Crystalfontz America, Incorporated

CFA633 v2.0 Hardware / v2.0 Firmware

CFA633 v2.0 Overview

**CFA633 v1.5c KU (USB) Back – USB Daughter Board**

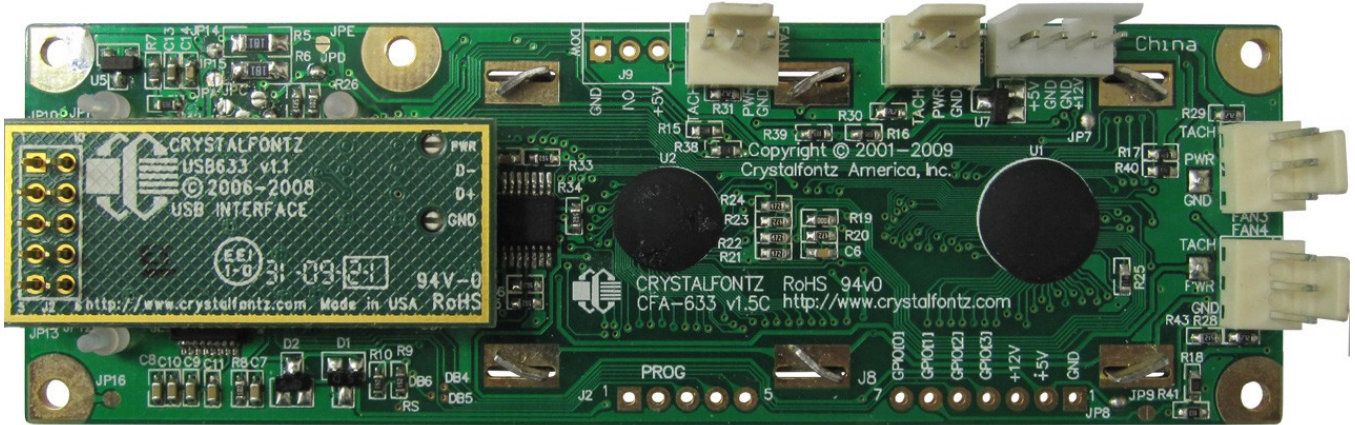
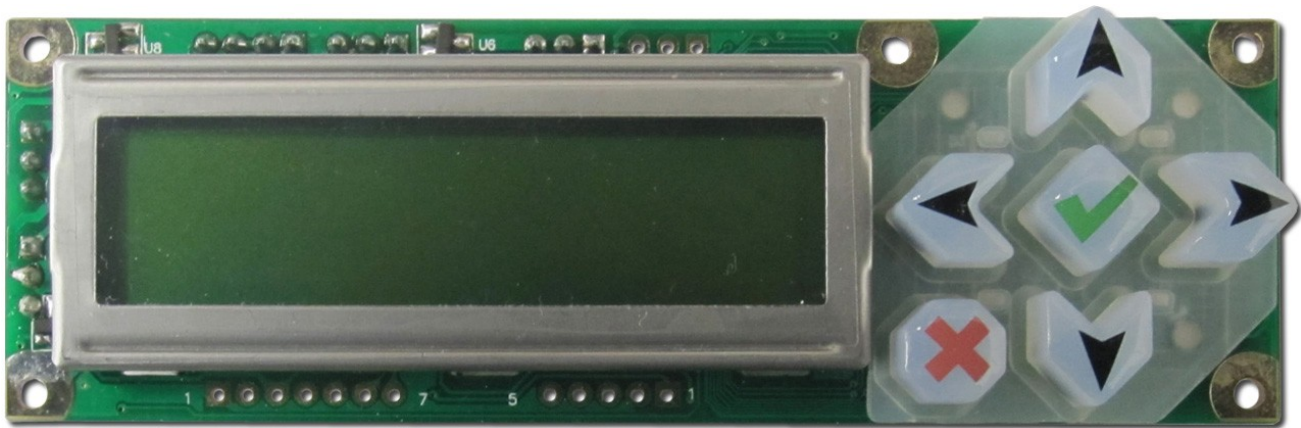
- USB interface is integrated and no longer requires a daughter board.
- Serial interface components are not loaded on USB interface modules.
- The serial interface is a build option.
- The keypad is now our "tall" keypad that has been used in our CFA533 and CFA635 modules. This adds approximately 1.5mm to the height of the keypad.
